**Car Stereo
Service Bulletin**

Model: XR-U550/U660

No.285

Subject: Antenna Remote Line Does Not Function

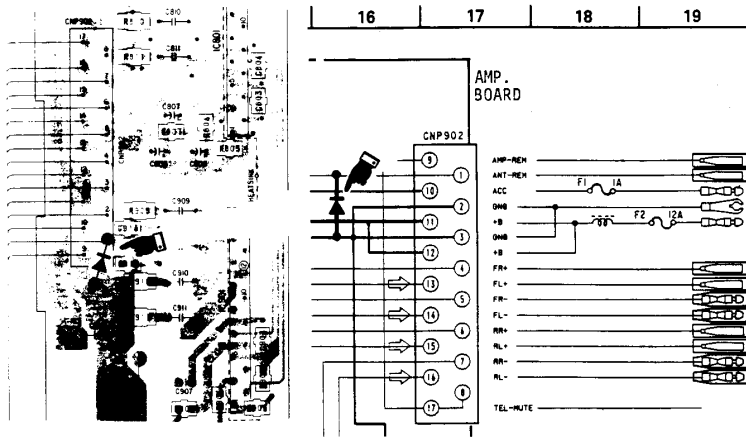
(22) The Antenna Remote line does not function because Q 522 is damaged.

Solution: Replace Q 522, and prevent it from becoming damaged again by adding an 11ES2 diode between the ANTENNA REMOTE line and ground on the AMP board.
